Mercer Island Center for the Arts (MICA) Transportation Impact Analysis
 Review Comments
 9/8/2016

P. Yamashita

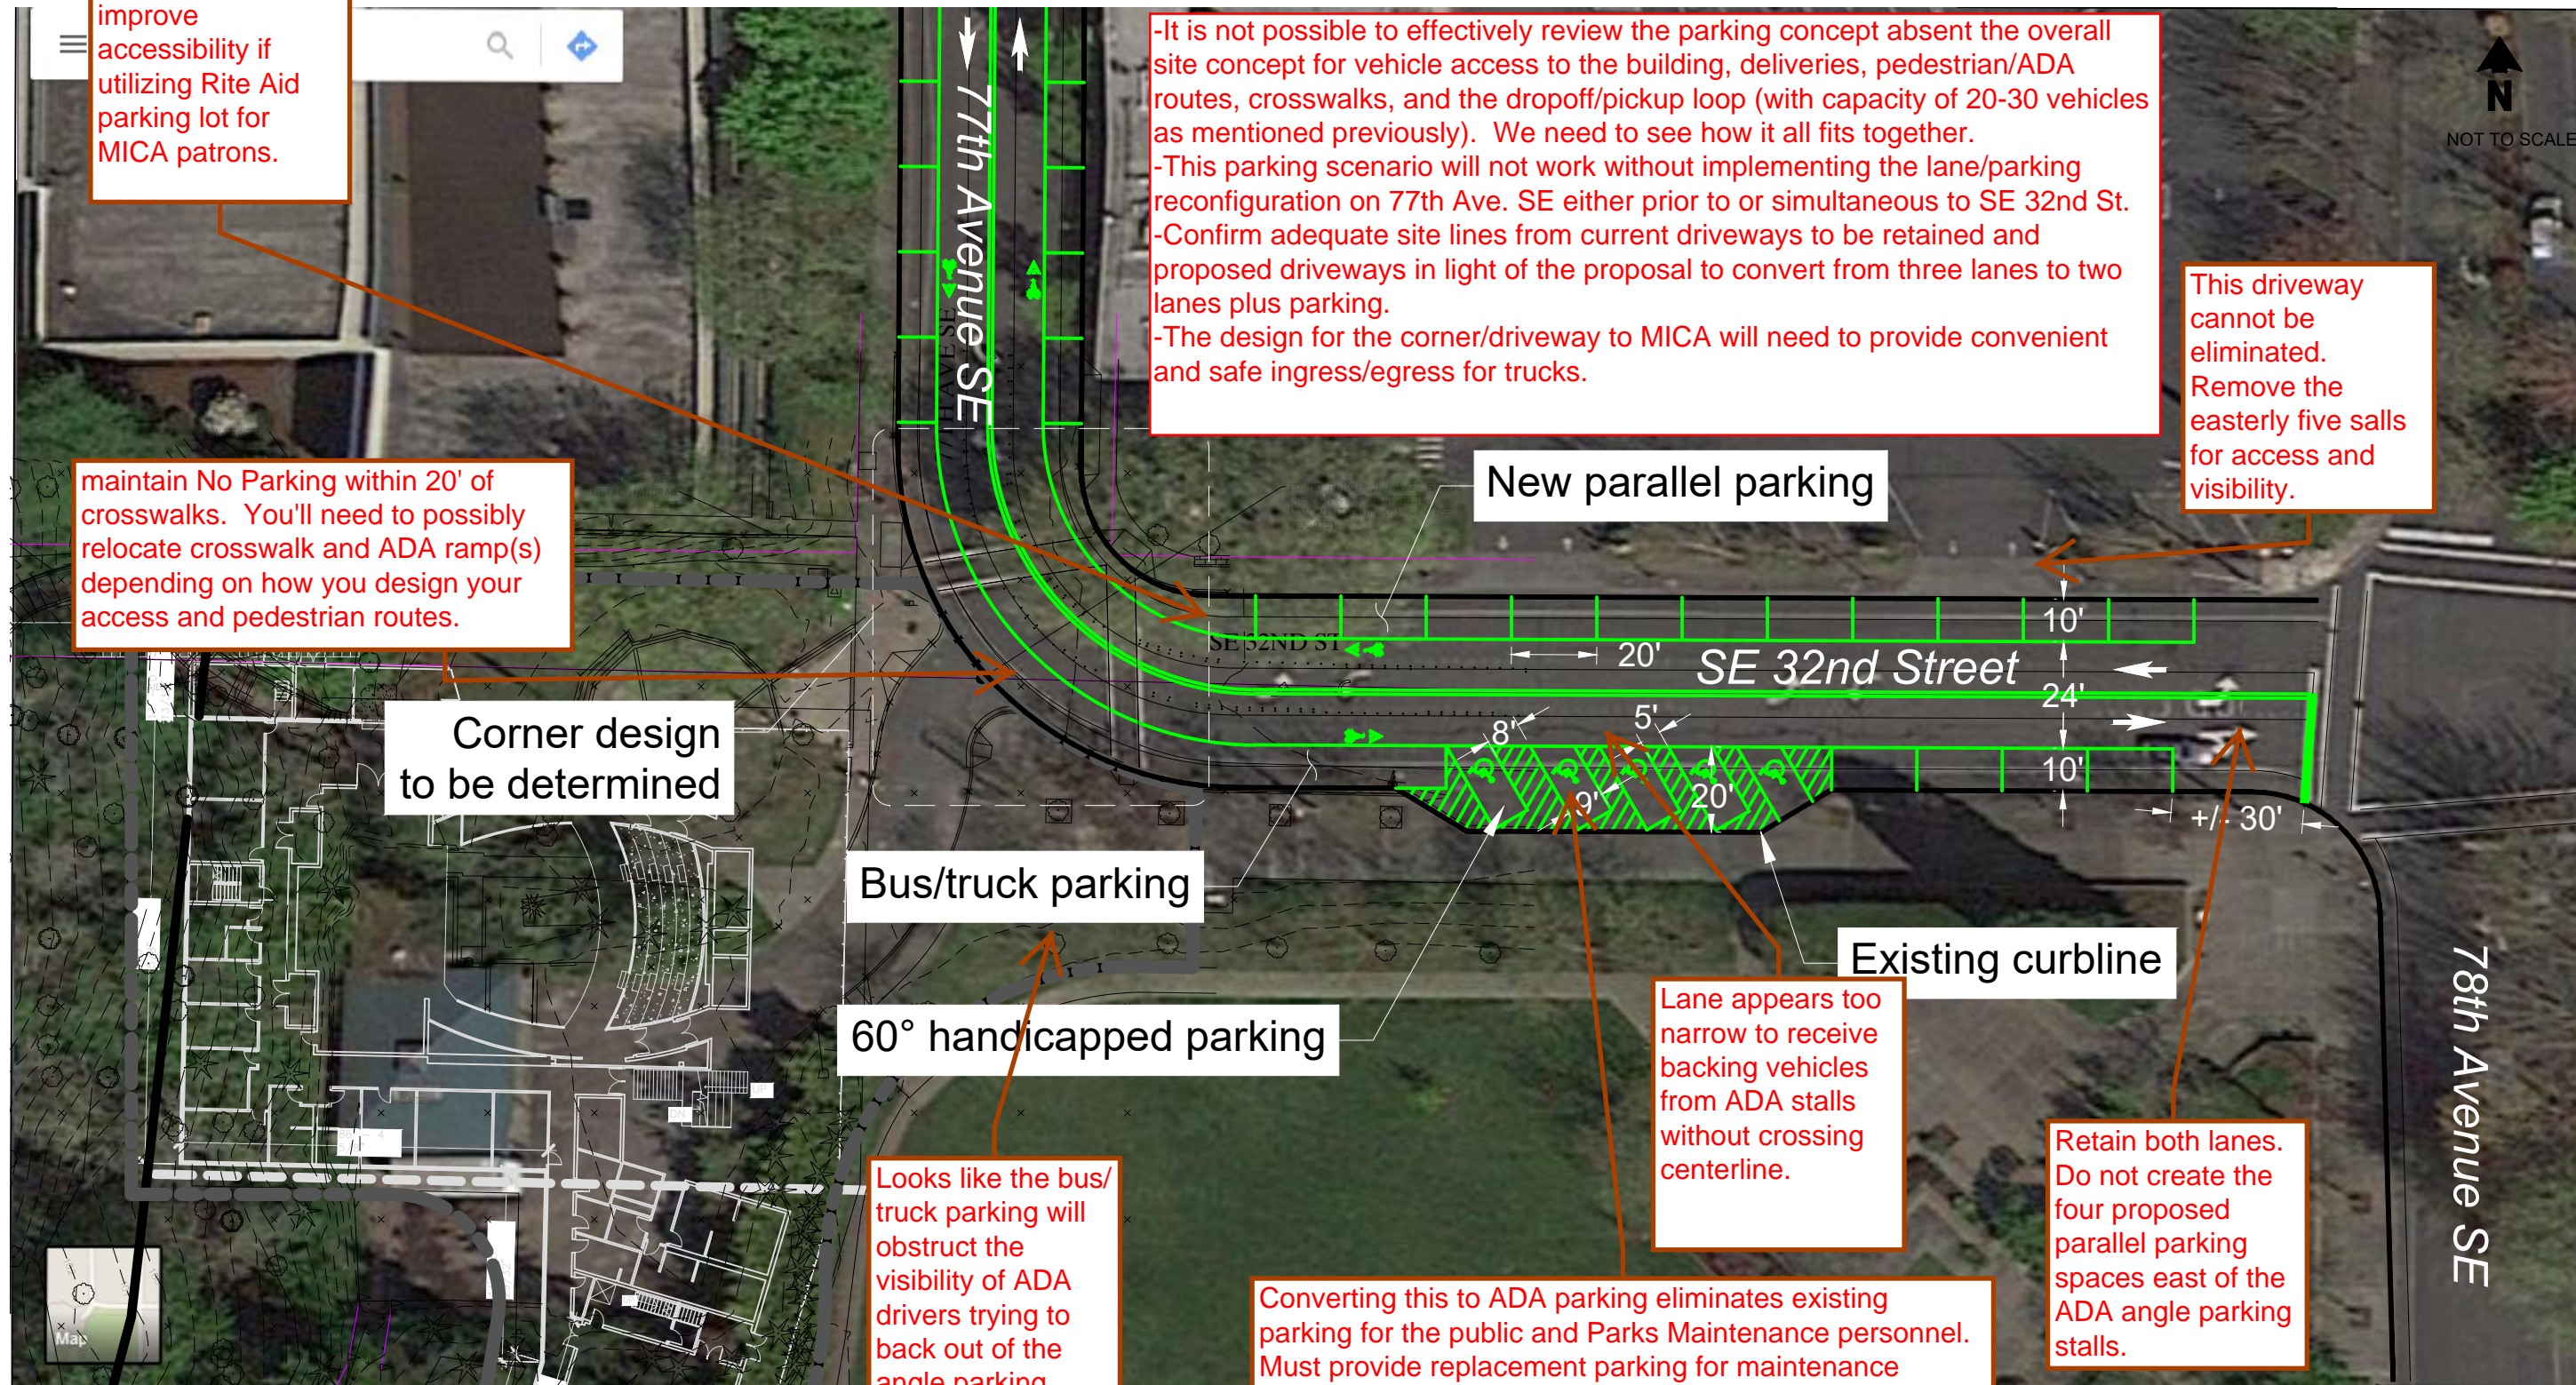
N #	Page/Sheet/Section	Comment	Notes/Response
		<p>engineer. These comments must be addressed and the plan updated. The July 26th comments are attached. Although the restriping of 77th Ave. SE to provide on-street parking is part of the City's long-term plan, it is not currently included in the Six-Year Transportation Improvement Program. Therefore, all costs associated with creating on-street parking will likely be the responsibility of MICA.</p>	
3	Accessible Parking Access	<p>Accessible parking is planned on street along SE 32nd Street. The closest accessible ramp is the crosswalk at 77th Avenue SE, approximately 70 feet west of the closet stall. Install new accessible ramps at the proposed parking area so that wheelchairs do not need to travel in the roadway to access the sidewalk.</p>	
4	TIA	<p>Refer to the redlined copy of the TIA for comments.</p>	
5	TIA pg. 17 (Pick-Up/Drop-Off Trips/Plan)	<p>This section is not specific enough. The plans submitted for the project depict the building, site improvements, an even on-street parking but do not show even a conceptual drop-off/pick-up area. Provide a plan that depicts and describes how pick-ups/drop-offs will be addressed, especially after school for the programs focused on children at the site. Show specifically where this will occur, how it will be managed daily (i.e. where cars will queue, if flaggers or other staff will be managing traffic flow so that it does not impede through traffic on 77th Avenue SE and SE 32nd Street), and how it interacts with on street parking including ADA parking. The project team previously described it as a "loop" with a capacity of at least 20 to 30 vehicles. The appendix shows that the peak occurrence of pick-up/drop-off is at 9:00 p.m. Show that there is adequate illumination throughout the proposed pick-up/drop-off zone so</p>

Mercer Island Center for the Arts (MICA) Transportation Impact Analysis
Review Comments
9/8/2016
